DOW CHEMICAL TRIGA
RESEARCH REACTOR
LICENSE NO. R-108
DOCKET NO. 50-264

REVISED SAFETY ANALYSIS REPORT,
TECHNICAL SPECIFICATIONS, AND
RAI RESPONSES (2/11/2011)

Subject: Dow Chemical Company- Response to the Request for Additional Information for the renewed license of the TRIGA research reactor. License No. R-108; Docket No. 50-264

Response to the request for additional information
The Dow Chemical Company
February 2011

Figure 4. Upper grid

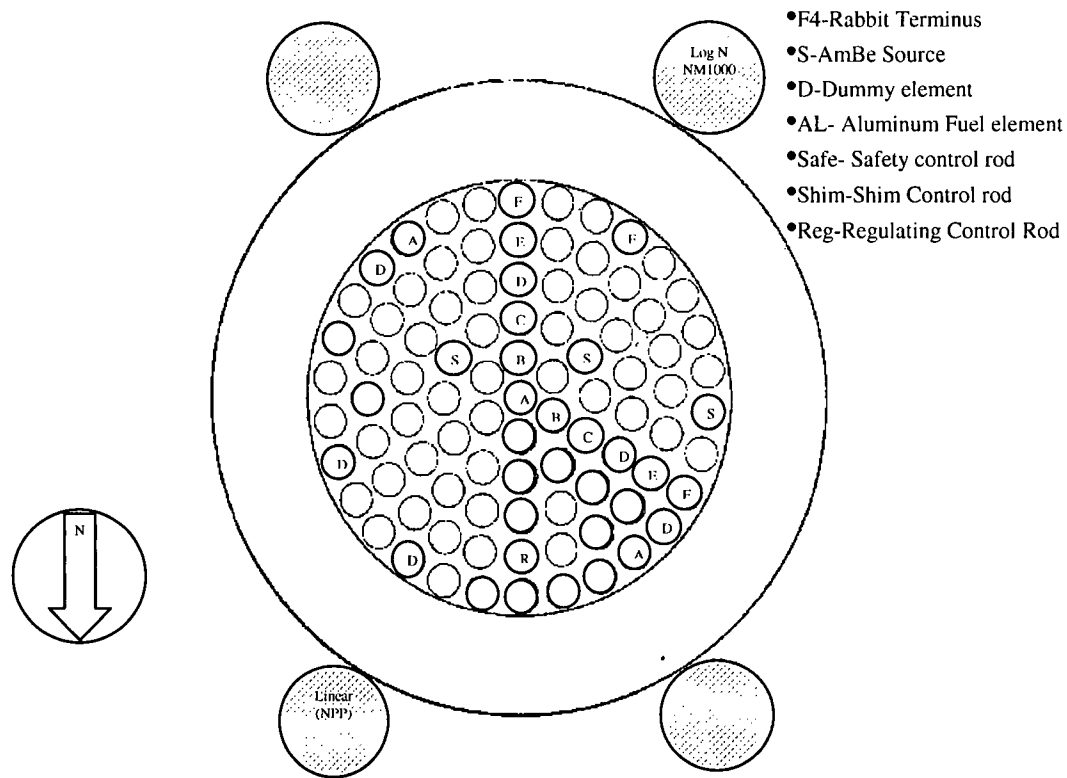
11. NUREG-1537, Part 1, Section 4.2.5, "Core Support Structure" requests the applicant to provide design information pertaining to the core support structure. DTRR SAR, Chapter D, does not provide sufficient information. Please provide figures depicting the upper and lower core plates and provide the dimensions and locations of all penetrations that allow coolant to flow through them.

Two aluminum grid plates fix the position of fuel elements, dummy elements and neutron source. Figure 4 is the schematic drawing of the upper grid plate with the position of the control rods, pneumatic transfer location and source indicated. The upper plate is $\frac{3}{4}$ inch aluminum and 1.5 inch diameter holes to position the fuel, dummy elements, control rods, etc. The bottom plate is $\frac{3}{4}$ inch aluminum and has holes to receive the end pins of the fuel and dummy elements. Thirty-six holes for the natural convection cooling are found on the lower grid plate. The water passes through the upper grid plate by means of the gap between the triflute section of the fuel and the upper grid plate. The penetrations on the lower grid plate are in concentric rings with 7, 12, and 17 holes, respectively. Figure 5 is a photograph of the lower grid plate. This photograph substantiates the as built drawings given by General Atomics, and previous Safety Analysis Reports submitted by The Dow Chemical Company. Figure 5 is a photograph of the lower grid plate.

Figure 6. Block Diagram Cooling System
A, B, C, and D are valves that can be used for isolation

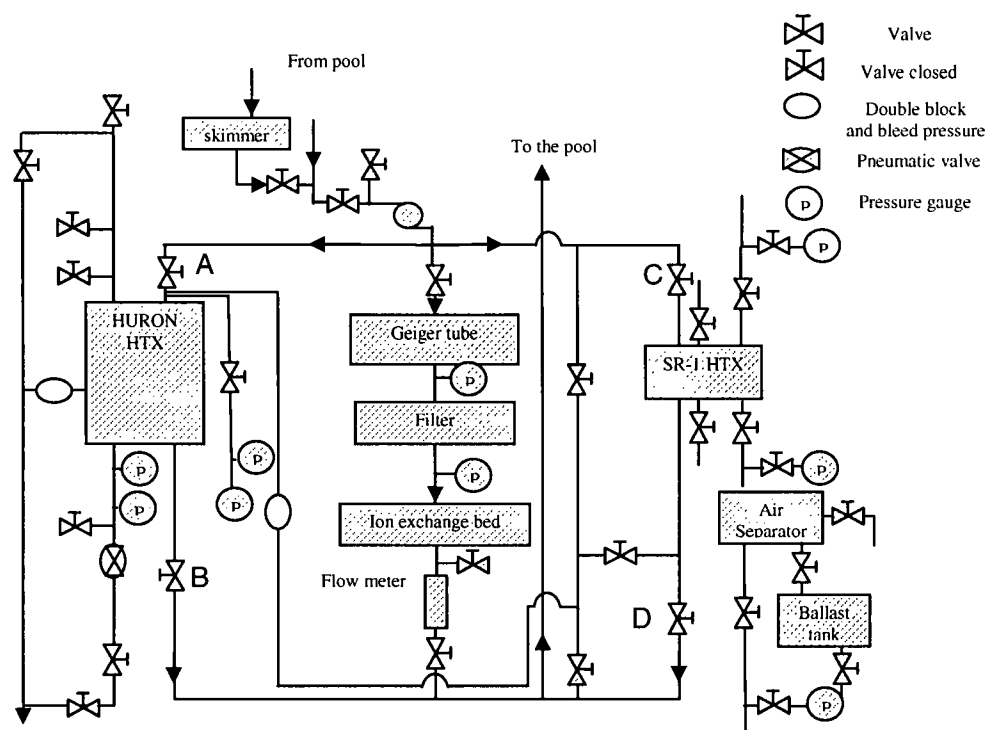
23. NUREG-1537, Part 1, Section 5.3, "Secondary Coolant System" requests the applicant to provide a description of the secondary coolant system, including schematics and flow diagrams for the secondary coolant system.
- 23.1 DTRR SAR, Section E.1, states that "the heat rejection systems can be operated independently or in tandem." DTRR SAR, Section E.1, Figure 6, Reactor Coolant System, shows no valve arrangement that

accomplishes these functions. Please provide schematics and flow diagrams for the secondary system, including valves, which show how the secondary coolant system can be operated independently or in tandem.

- 23.2 DTRR SAR, Section E.1, does not provide sufficient information describing the secondary system. Please provide a more detailed description of the secondary coolant system and describe how primary to secondary leakage would be detected.

- 23.2 Figure 6 is of the heat exchange system installed at the DTRR. The reactor is cooled by natural convection. Thus, the system is not required for operation.

- 23.3 Makeup water is added directly to the pool and monitored. Pressure in pool water lines and coolant lines are monitored. The pool water line is kept at a lower pressure than the coolant lines. Huron water leaking into the pool would be indicated by changes in conductivity, pH, monthly water sampling and the Geiger tube installed on the water treatment line. Leaks would also be indicated by changes in pressure monitored on the system. The secondary heat exchange system is rated at 1 megawatt. The chiller is located on the east side of building 1602. This system can be operated manually or set to automatically start when the pool water reaches 27 °C. The system shuts down at 22 °C. The system is dedicated to the reactor. The uncertainty in the measurement is 2 °C.

Figure 7. Detector ranges

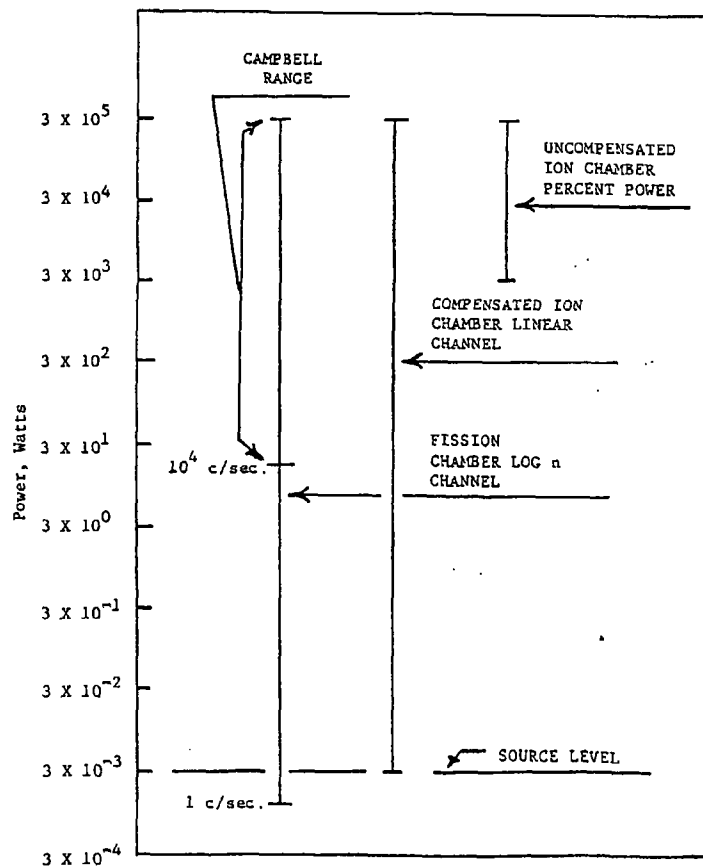
30. NUREG-1537, Part 1, Section 7.3, "Reactor Control Systems (RCS)" requests the applicant to provide information regarding the functions of the RCS. DTRR SAR, Chapter G, does not provide sufficient information.

General Atomics provided both the NM1000, and NPP1000 used as power

monitors for the DTRR. The combined range of the two instruments covers from 3×10^{-4} up to 3×10^5 Watts. Figure 7 is the range of the two instruments.

Figure 9. Block Diagram of the console

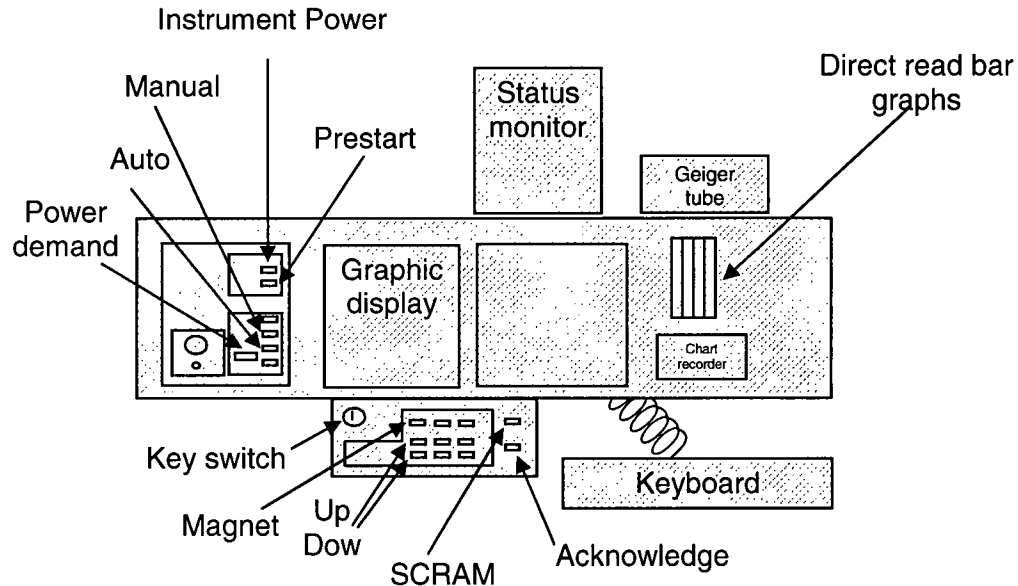
32.3 Please provide drawings or photographs showing the arrangement of the display instruments and console control equipment.

32.3 Figure 9 is a block diagram of the console.

Figure 11. HVAC for the DTRR reactor room.

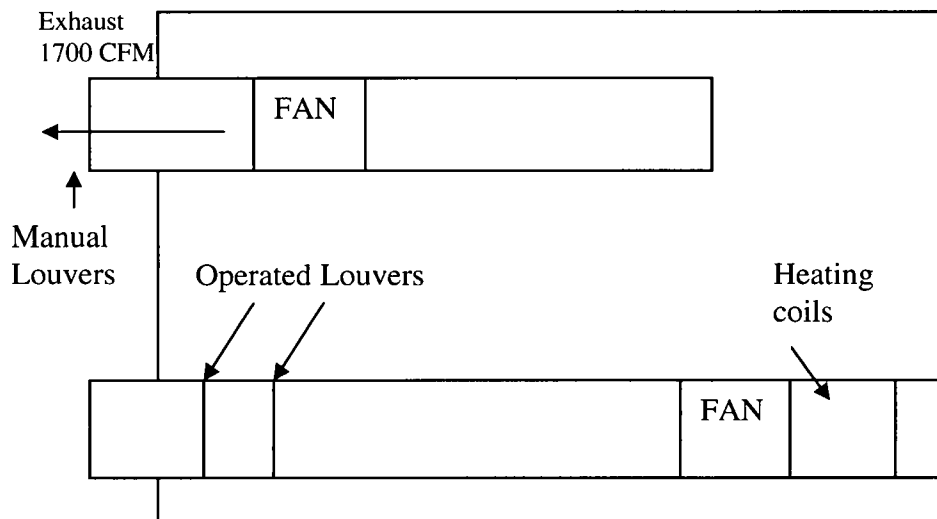
34. NUREG-1537, Part 1, Section 9.1, "Heating, Ventilation and Air Conditioning System" requests the applicant to provide a description of the heating, ventilation and air conditioning system (HVAC) and any manual or automatic functions. There is a brief description in DTRR SAR I.1 regarding this function with no schematics or illustrations. Please provide a more detailed description of the HVAC system and system functions and provide schematics of the HVAC system.

The HVAC for DTRR is Figure 11. The inlet to the reactor room is located to the north side of the reactor room. The outlet is located on the east wall of the building. The ventilation system inlet is equipped with a set of louvers that can be shut from the control room by the operator if necessary to isolate the reactor room. The exhaust is also equipped with a set of louvers that can be shut manually from the exterior of the building. The fume hood exhausts are separate from the HVAC system.

Figure 6.1. Administration

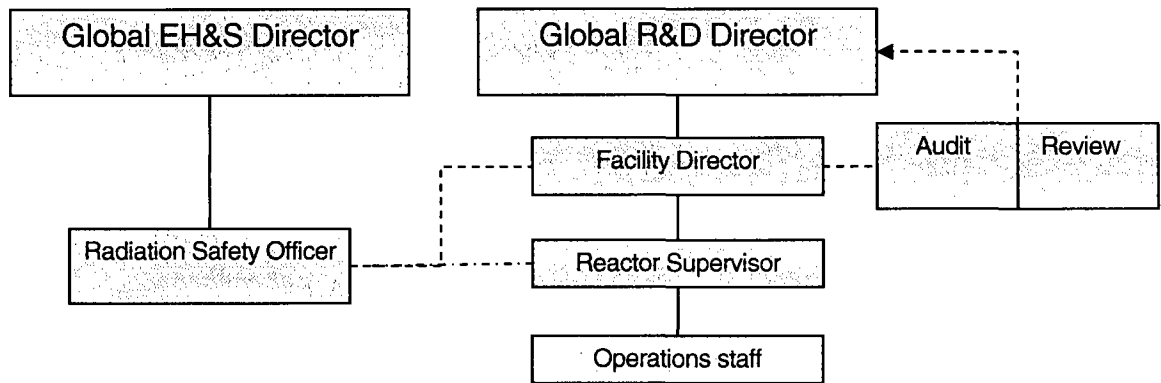
- 65.1 ANSI/ANS-15.1-2007, Section 6.1, “Organization” recommends organizational structures including levels and reporting authority. DTRR TS Figure 6.1, the DTRR organization structure, includes no level 3 or 4 staff and differs from Figure 8.0 of the DTRR SAR.

65.1. Figure 8 of the SAR is the reporting structure for the reactor operations staff and does not include the reporting structure for the Radiation Safety Officer. Figure 6.1 of the TS has been changed to comply with ANSI/ANS-15.1. Figure 6.1 includes the chain of command for the Radiation Safety Officer.
